CENPS-OP-DMMO

MEMORANDUM FOR RECORD 13 February 1994

SUBJECT: DETERMINATION ON THE SUITABILITY OF DREDGED MATERIAL RETESTED FOR THE U.S. NAVY'S PIER D DREDGING PROJECT , BREMERTON, WASHINGTON (OYB-2-012791) FOR DISPOSAL AT A PSDDA UNCONFINED OPEN-WATER DISPOSAL SITE.

FIGURE 3

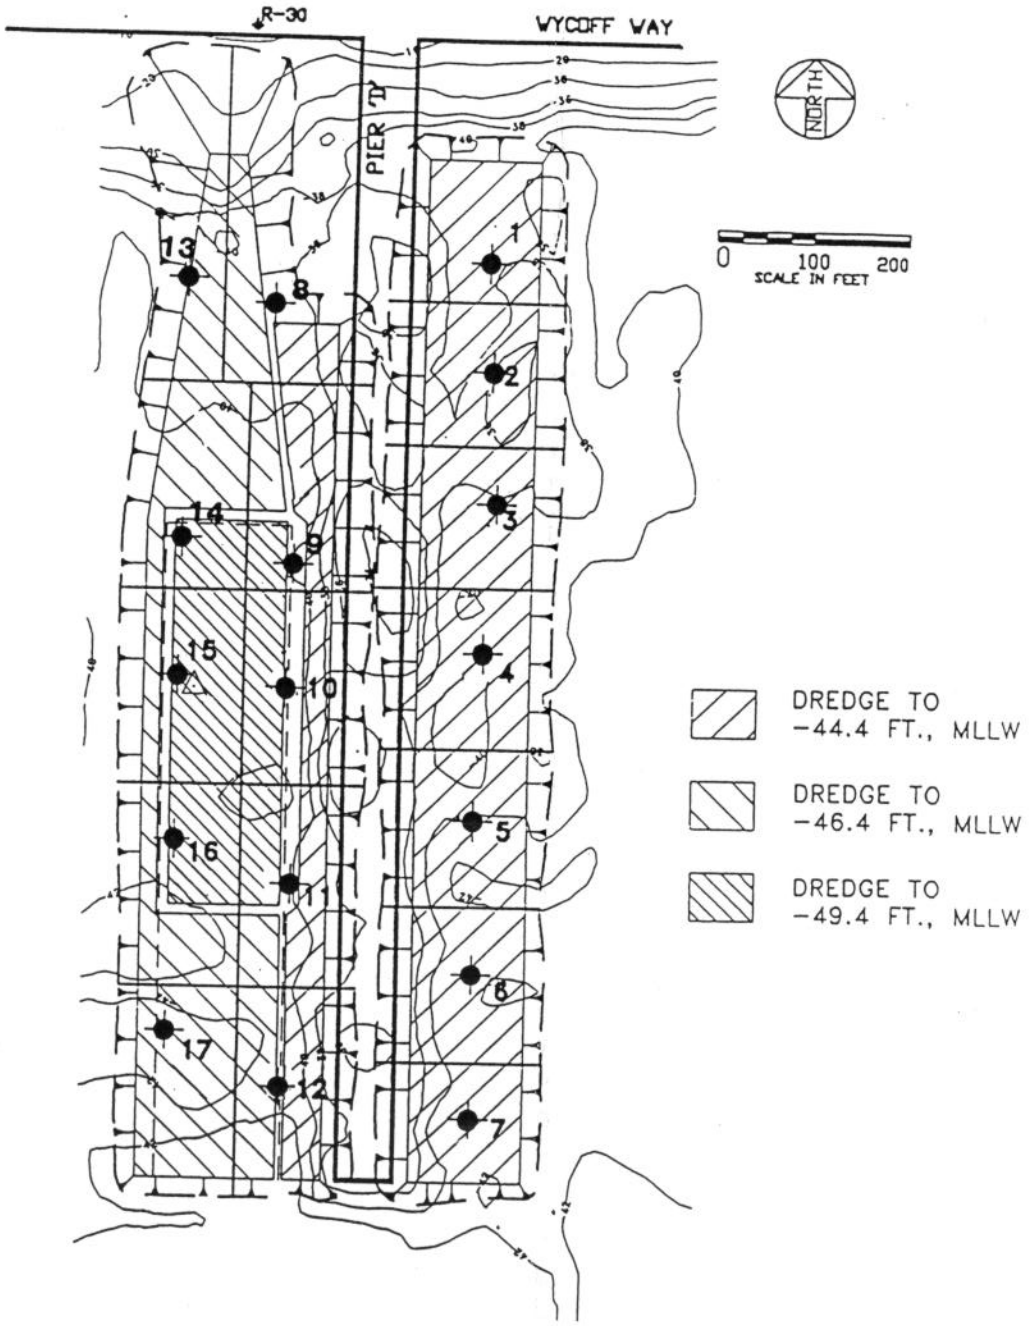
10. The Agencies concluded based on the above discussion and summary of sediment chemical and biological retesting results for the Navy's Pier D dredging project in Sinclair Inlet, that 51,700 cubic yards is suitable (DMMU S1, S10, S11, S12, S13, S15, S17, C1, C3, C4) and 53,400 cubic yards is unsuitable (S2, S3, S4, S5, S6, S7, S8, S9, S14, S16, C2, C5) for unconfined open-water disposal. Table 8 summarizes the suitable and unsuitable volumes for the surface and subsurface. Figures 1 and 2 also depict the plan view of suitable and unsuitable DMMU characterized.

FIGURE 4

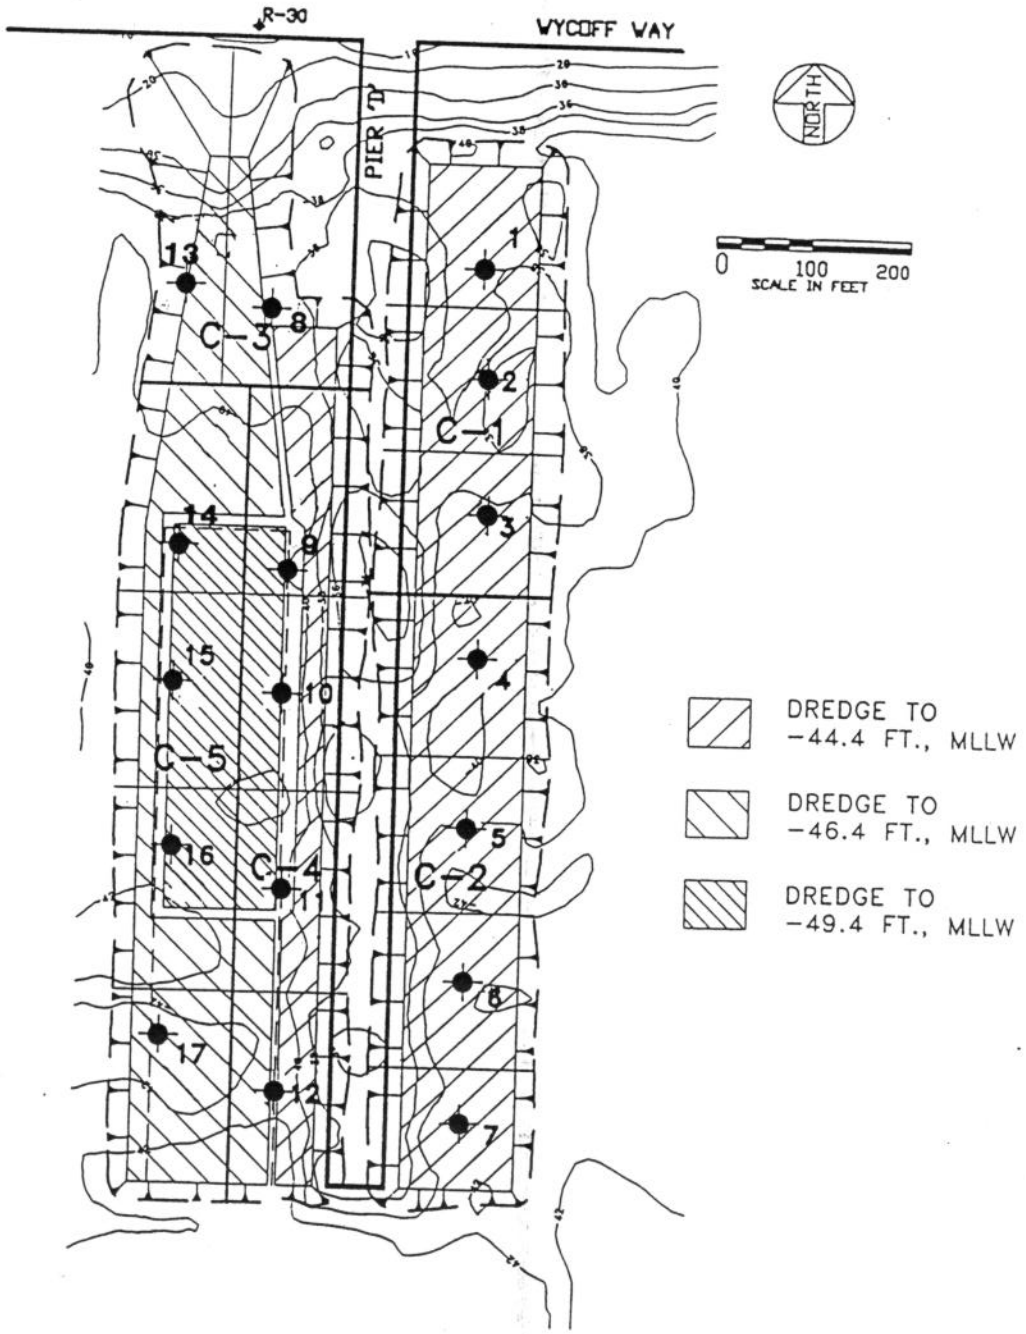
9. The following discussion addresses the need to analyze archived samples (Z samples) underlying failed subsurface DMMU C2 and C5. The requirement to characterize samples representing the post dredging surface material is deemed necessary when subsurface sediment quality and expressed surface quality is a concern (Phase II MPR, page 5-34, paragraph 5.7). Comparative surface DMMU sediment chemistry overlying these two DMMU is notably higher than the subsurface sediment quality as depicted in Table 7. Two of the surface DMMU (S15 and S17) overlying C5 passed PSDDA disposal guidelines, but exhibited chemical concentrations either equal to (S15) or higher (S17) than C5 (Table 7). All four surface DMMU overlying C2 failed PSDDA disposal guidelines and exhibited markedly higher chemical values than C2, which had no SL exceedances. In the case of DMMU C5, the sediment failed PSDDA disposal guidelines based on a single hit from the sediment larval bioassay. However, a separate QA/QC sediment larval analysis of this DMMU by an independent testing lab (Northwest Aquatic Sciences) failed to confirm the toxicity for this bioassay. Therefore, the PSDDA agencies have determined based on the aforementioned facts, that analysis of archived Z samples would not be required based on the exhibited overall pattern of contamination and chemical levels using best professional judgement.
